**City of Pembroke Pines
 Planning & Economic Development Department
 601 City Center Way 3rd Floor
 Pembroke Pines FL, 33025**

Agenda Date:	May 14, 2026	Application ID:	MSC 2025-0029
Project:	Acura Canopy Extension	Project Number:	N/A
Project Planner:	Julia Aldridge, Planner / Zoning Technician		
Owner:	Boo Inc C/O Craig Zinn Auto Group	Agent:	Monica Nunez
Location:	15601 Pines Boulevard	Commission District:	3
Existing Zoning:	B-3 (General Business)	Existing Land Use:	Commercial
Reference Applications:	SP 2005-07, SP 2004-64, PH 2004-06		
Applicant Request:	Extension of an existing canopy.		
Staff Recommendation:	Approval		
Final:	<input checked="" type="checkbox"/> Planning & Zoning Board		<input type="checkbox"/> City Commission
Reviewed for the Agenda:	Director: 	Assistant Director:

Monica Nunez, agent for owner Boo Inc C/O Craig Zinn Auto Group, is requesting approval for the proposed expansion of the existing Acura service lane canopy. Acura of Pembroke Pines is generally located north of Pines Boulevard and east of Dykes Road.

Sheet Title
ARCHITECTURAL SITE PLAN

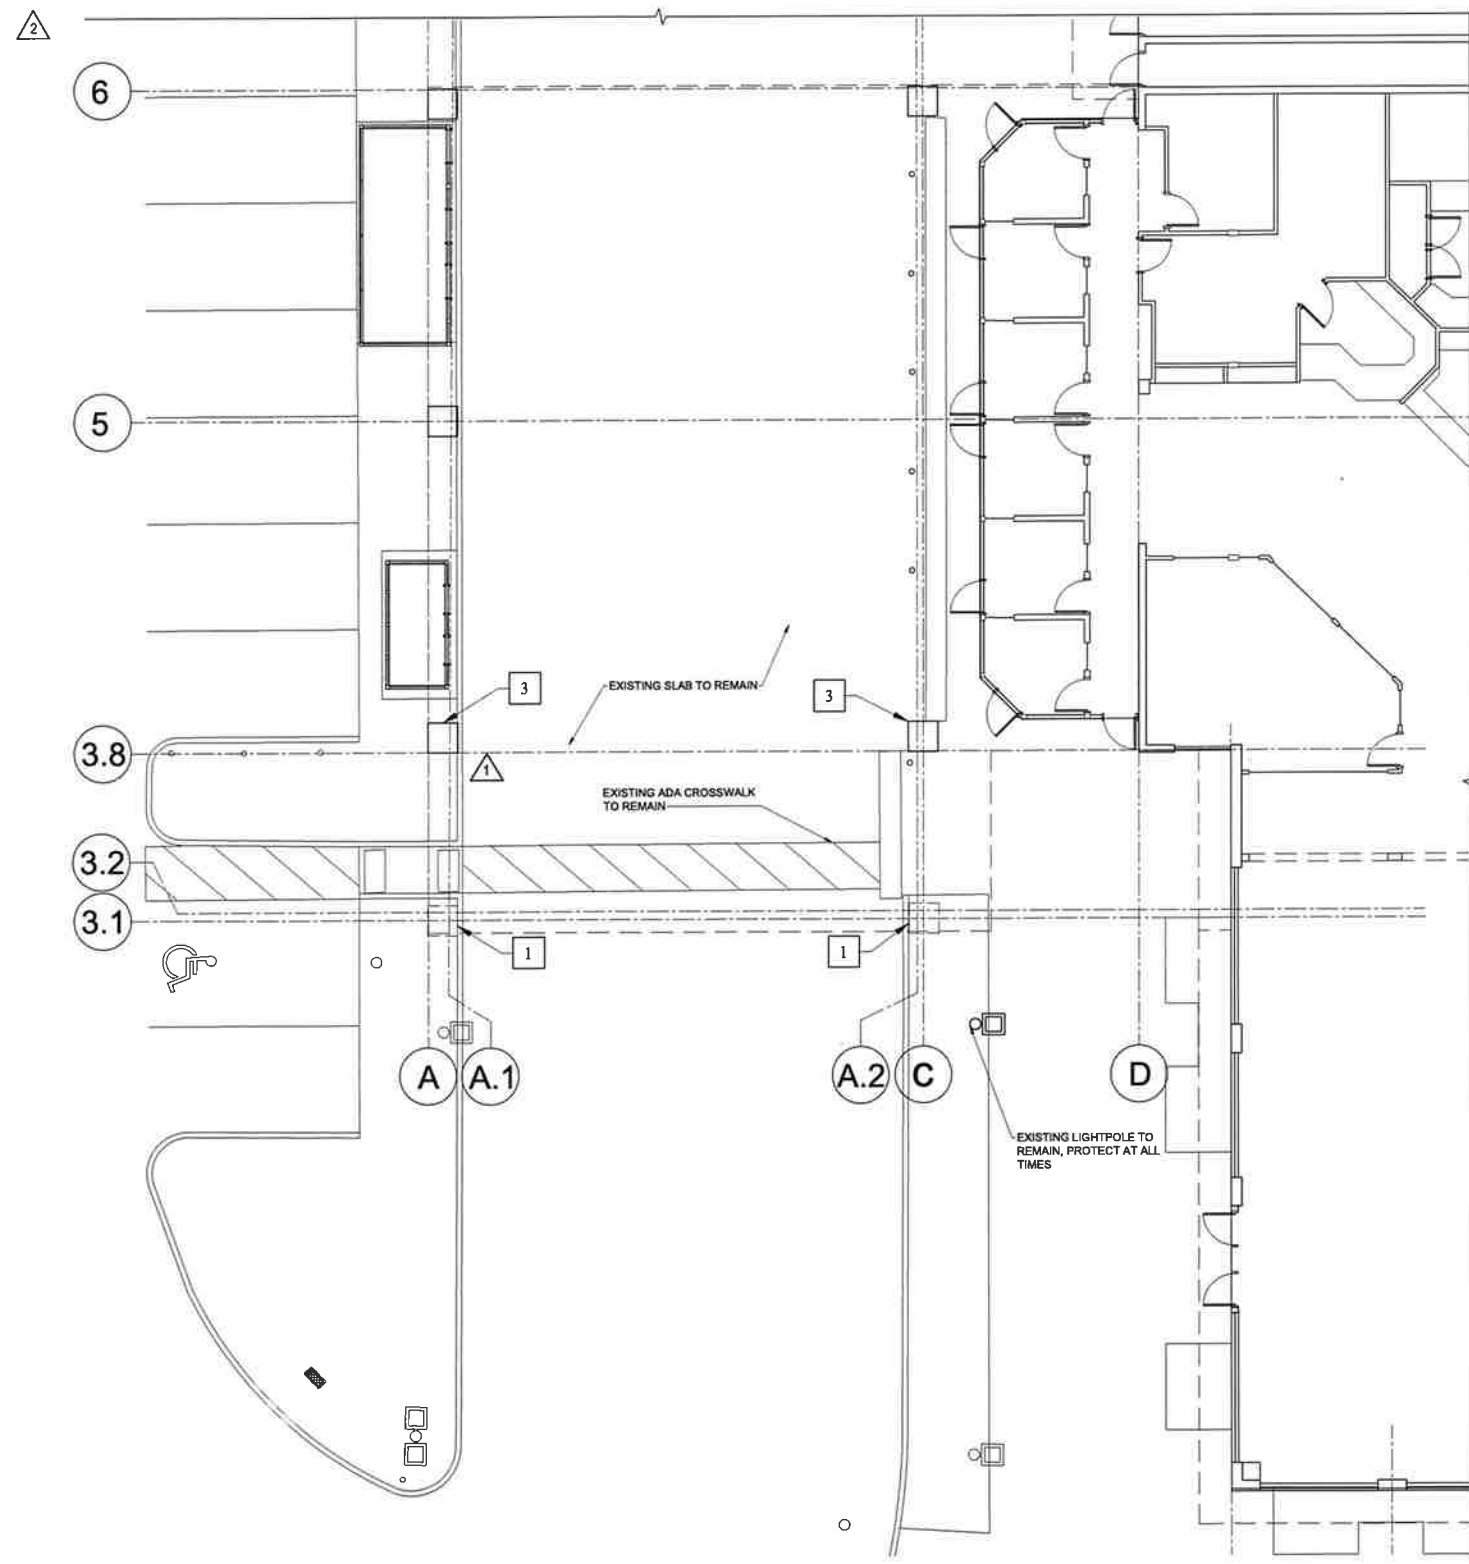
1. Remove the existing ADA parking stall on the east side of the building and relocate it to the front entrance/south side of the building where the other ADA parking spaces are located, as the current accessible route requires a diagonal crossing through a high-traffic area that is not a public circulation space. The 2010 ADA Standards for Accessible Design require that accessible routes coincide with or be located in the same area as general circulation paths (§206.3) and do not permit accessible routes to pass through spaces not intended for public pedestrian use (§206.2.1, Advisory); therefore, diagonal crossings through high-traffic vehicular areas are not acceptable when a safer and more direct accessible route to the entrance is readily achievable.

R: Plans have been updated so as not to disturb the existing ADA access route thus resolving the requirement for civil engineering review. This parking space and access route were approved in their current location in the previous DRC application and will not be disturbed. All striping, asphalt, curb cuts and landscape are existing to remain.
